[Darshan_04_0917.pdf](#) (PSE state machine Part A- Using CLASS_PROBE in Figure 145-15/16)

Comment (i-198, i-269, i-406)

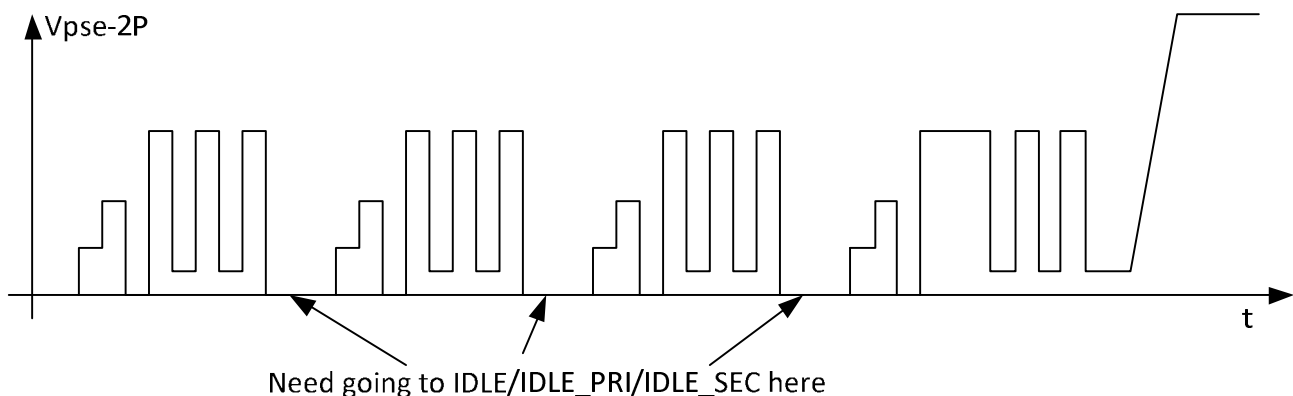
Some PSE architectures are generating sequences of detection + classification events and waiting for the host to decide when to power on the port. This requires the class probe functionality and exit to IDLE in the classification state machines (for single-signature and dual-signature). Single-signature has global pse_reset input to IDLE so in this case, PSE can go to IDLE at any time. It is not the case in dual-signature.

As a result, we need to:

- (1) Add CLASS_PROBE_PRI/SEC functionality for primary and secondary.
- (2) Add global exit to IDLE_PRI/SEC by using pse_reset_pri/sec by changing the input to IDLE_PRI to $\text{sism}^*(\text{iclass_lim_det_pri} + \text{pse_reset_pri})$ it will do two things: pse_reset_pri and multi-true issue with IDLE_PRI and ENTRY_PRI. To implement same changes for secondary.

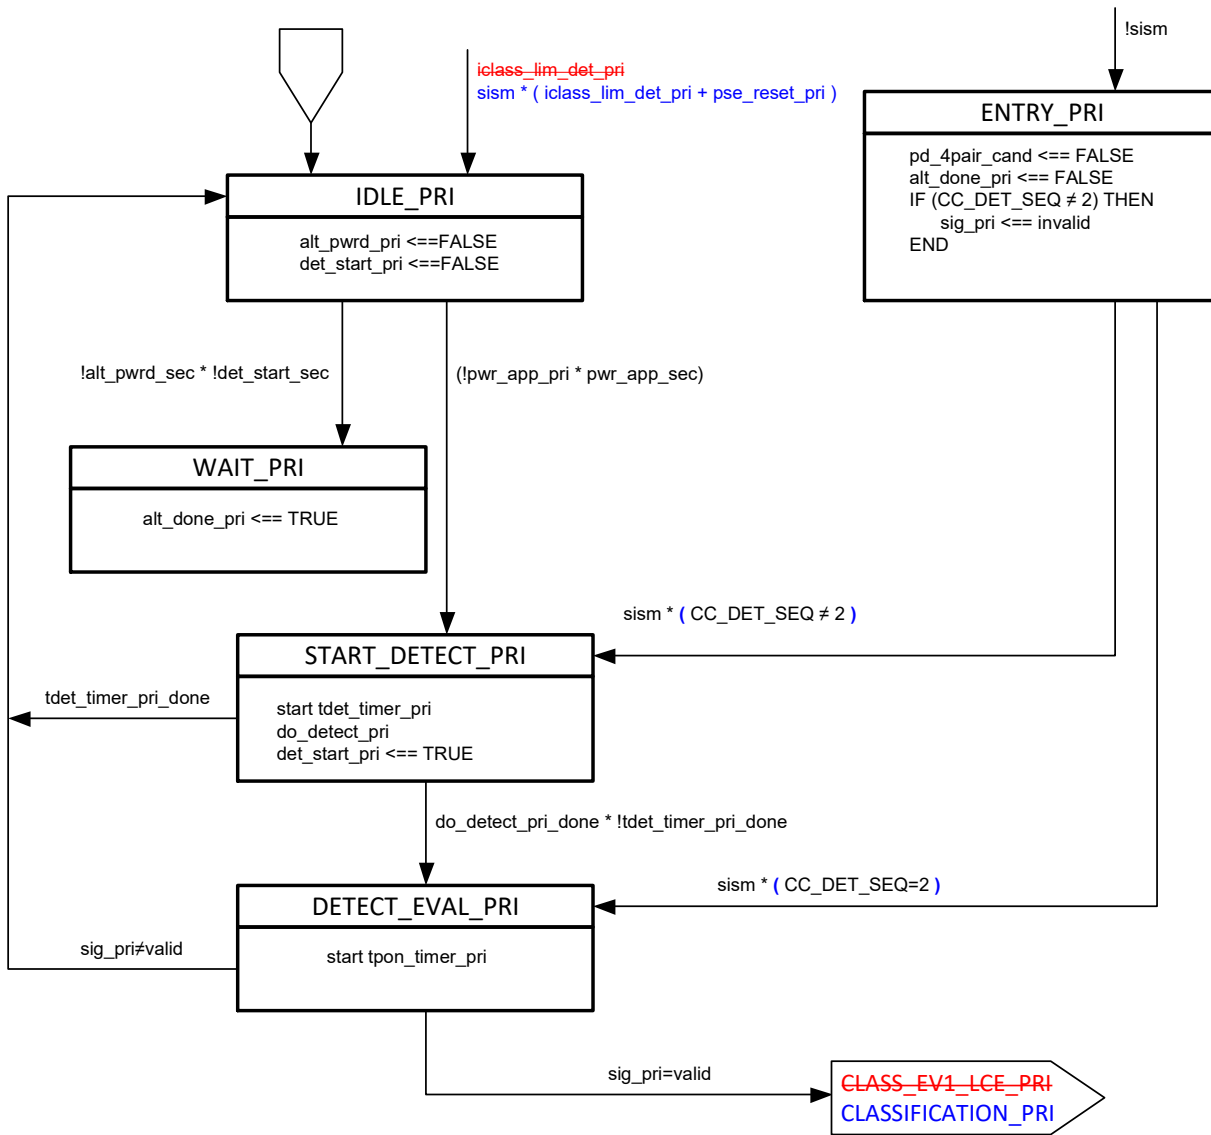
4. Make the following changes to the state machine in page 132

Global pse_reset_pri was inserted in the same way we did for single-signature.
 The variable sism was added as a condition for both iclass_lim_det_pri and pse_reset_pri. From logical operation point of view, sism is not required as a condition for iclass_lim_det_pri since iclass_lim_det_pri = TRUE only if we have do_classification_pri which can happen only if sism=TRUE, however we keep it as proposed for now until confirmation from simulation.

Figure 145-15—Primary Alternative dual-signature semi-independent PSE state diagram (continued)

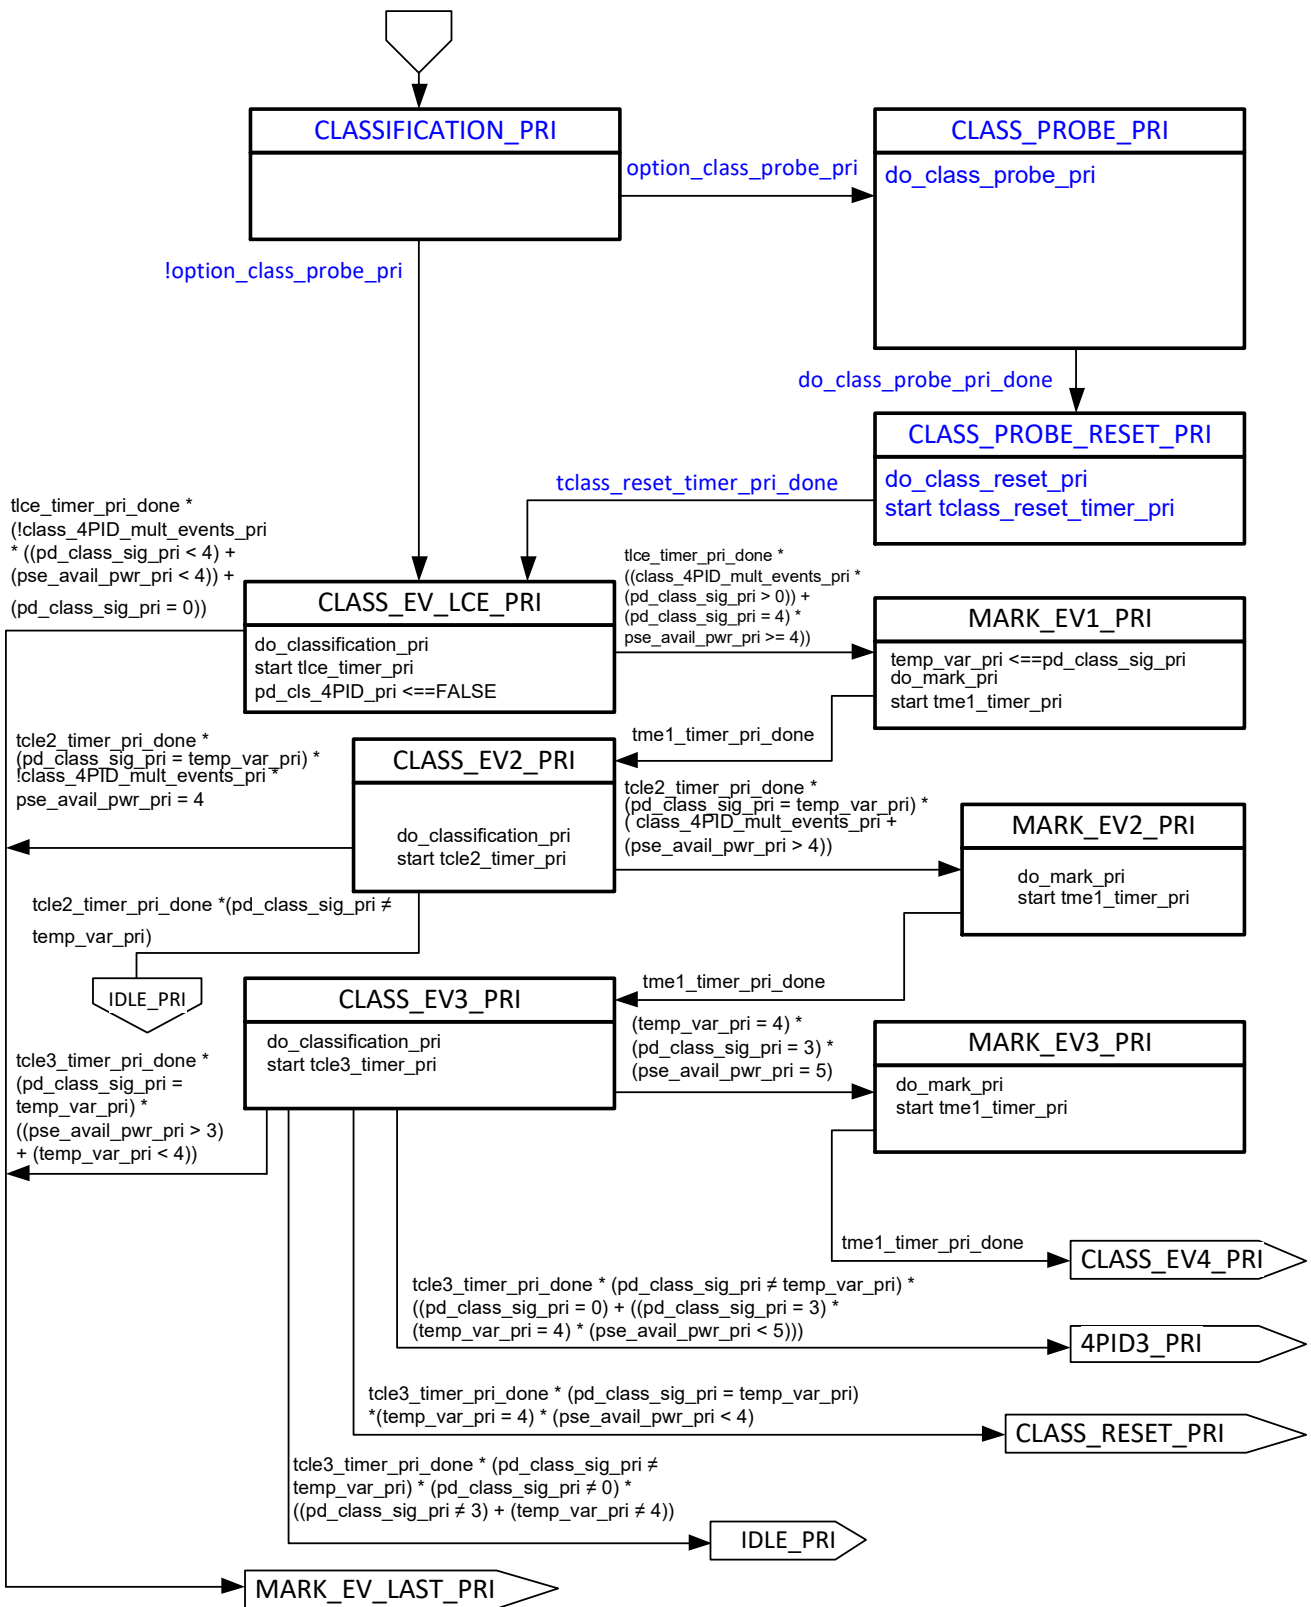
5. Make the following changes to Figure 145-15 page 133

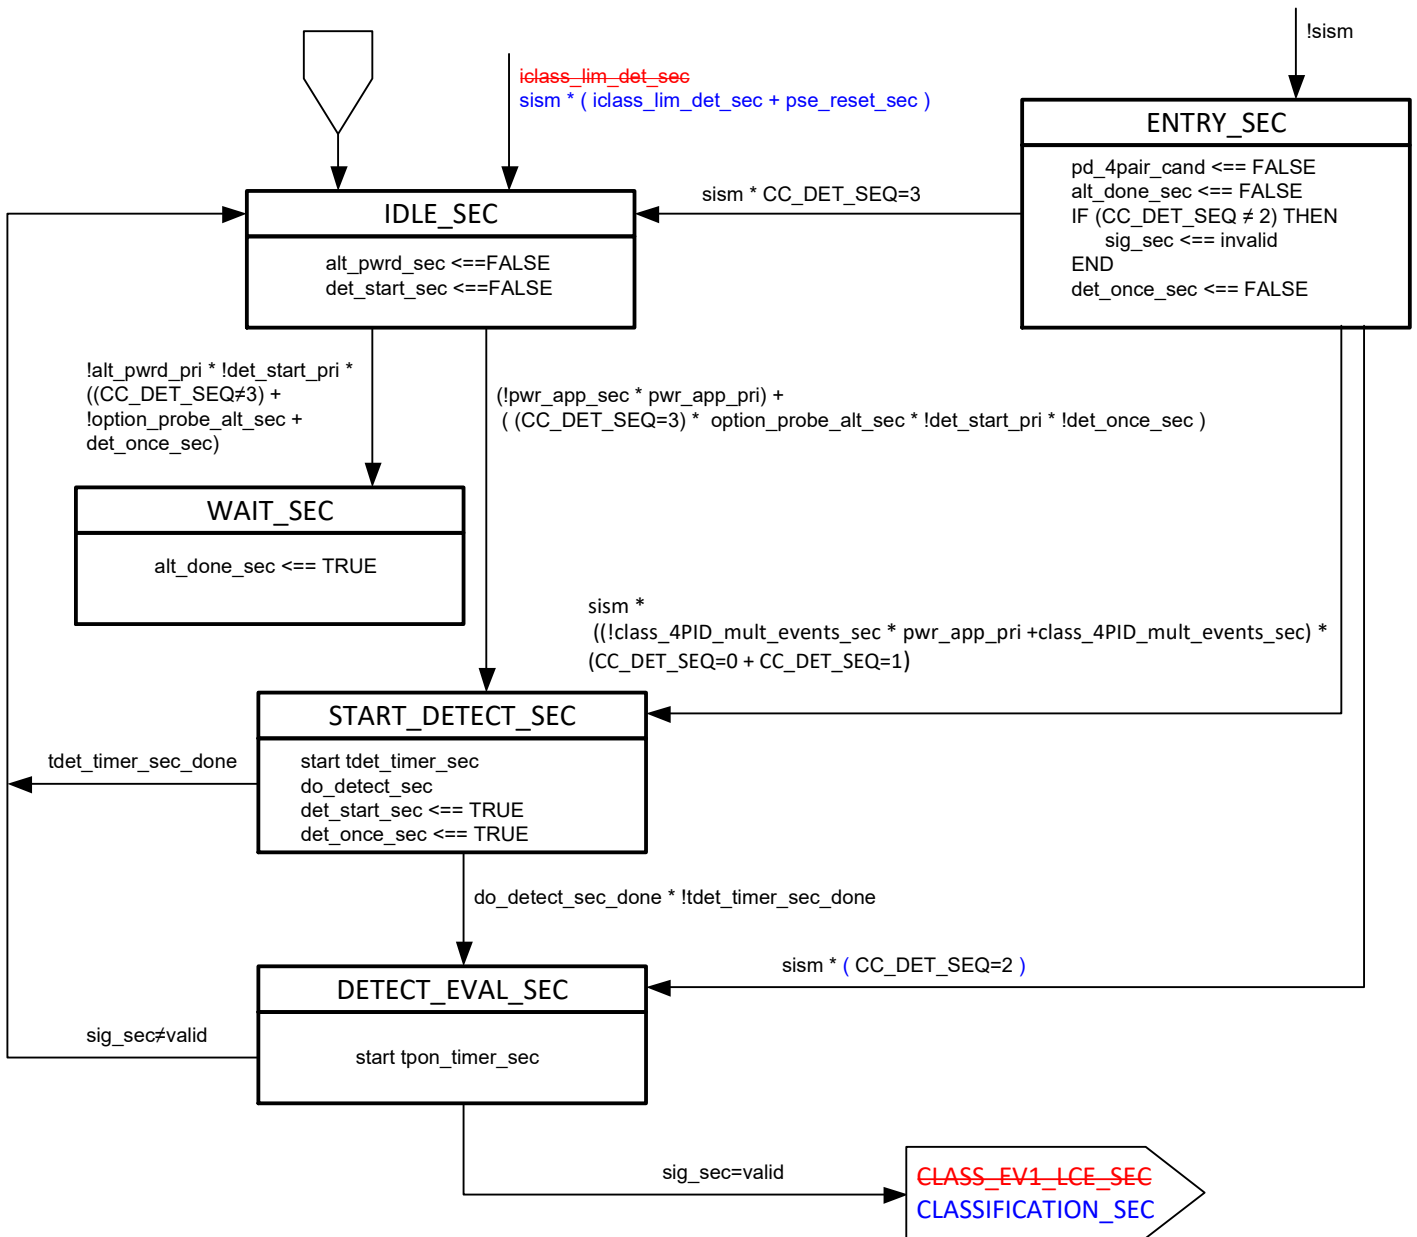
6. Make the following changes to the state machine in page 136

Figure 145-15—Primary Alternative dual-signature semi-independent PSE state diagram (continued)

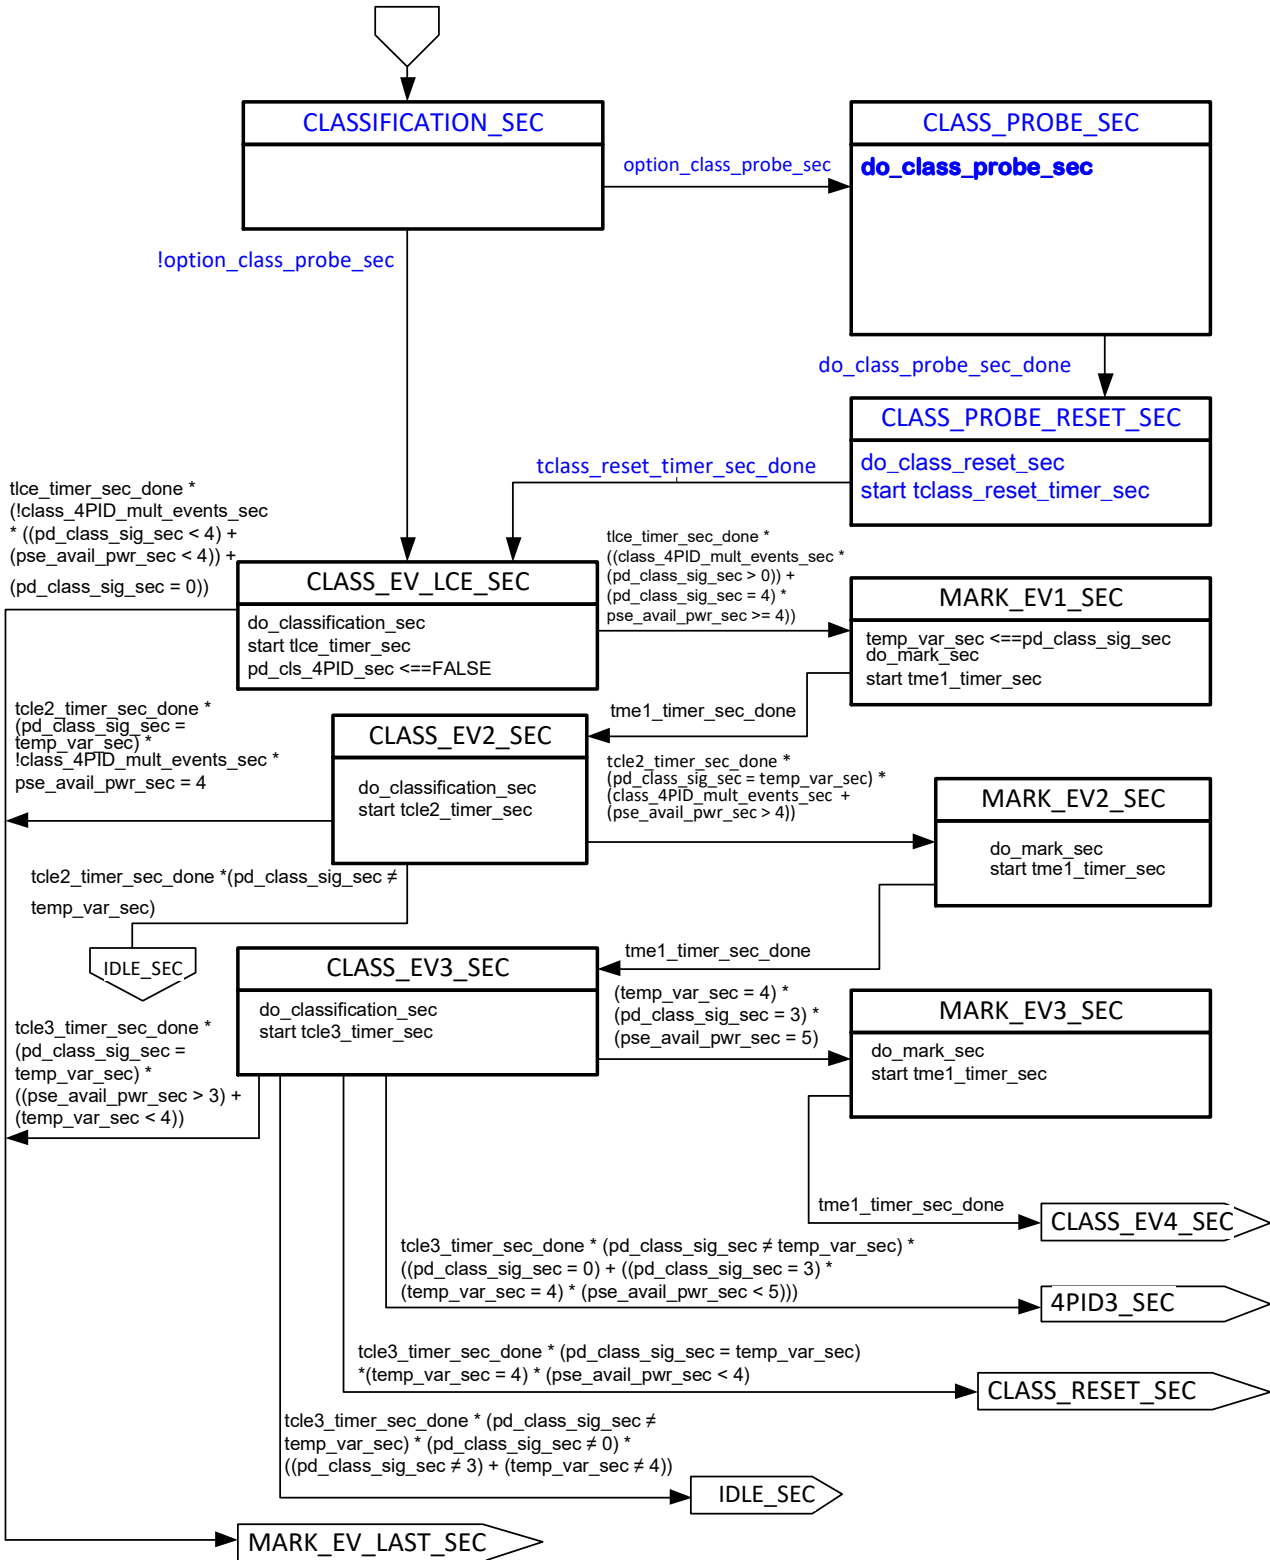
7. Make the following changes to Figure 145-15 pages 137
